# A303 Amesbury to Berwick Down

TR010025

**8.37.4 - Responses to the ExA's Written Questions  
- Cultural Heritage (CH.2)**

July 2019

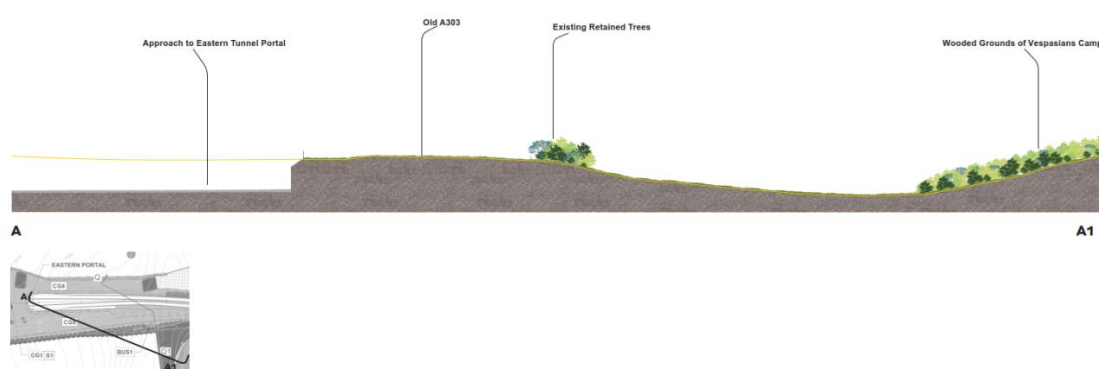
At the ASI it was clear that, despite the early summer foliage, visibility and aural connection exists between these historic assets and areas to the north. During autumn and winter, with the loss of foliage, the visual and aural link is almost certain to be greater. In any event, we cannot be sure the tree screen will remain in its present form. The settings of the assets, therefore, extend to the north and, at present, contribute to their significance through the enclosing backdrop they offer.

The Proposed Development may well harm the settings of these historic assets through greater visual prominence of traffic which would be elevated on the flyover, even if noise levels are contained. Also, as was clear at the site visit that the eastern portal, from which traffic would emerge on a rising incline, would be visibly intrusive, particularly at night with upward angled headlights. It would be likely to have an impact on the existing character and significance of Vespasian's Camp.

6. This setting, and its relationship to the existing road, would not change through the construction of the Scheme. The flyover as it crosses over the current Countess Roundabout is located c.470m to the east-north-east and is visually screened by woodland. This part of the Scheme would therefore not be visible from Blick Mead and would not harm the setting of Blick Mead.

7. The Scheme would be at grade as it passes the Blick Mead site to the north (as with the existing A303). The Scheme alignment has been optimised past the Blick Mead archaeological site, to avoid land-take and to keep the road at existing grade. Therefore, any views of an increased amount of traffic would be in the direct context of existing views of traffic. The sight of an additional number of vehicles would not result in a greater visual prominence of the road and it would not impact the setting of Blick Mead.

8. In terms of the aural connection, once the Scheme is operational, Figure 9.24 [APP-167] indicates a negligible increase in noise (the light blue hatching in Figure 9.24).

9. The ES therefore reports No change and a Neutral Effect on the Blick Mead archaeological site (Appendix 6.8 – Cultural Heritage - Summary of non-significant effects [APP-217, page 5]).
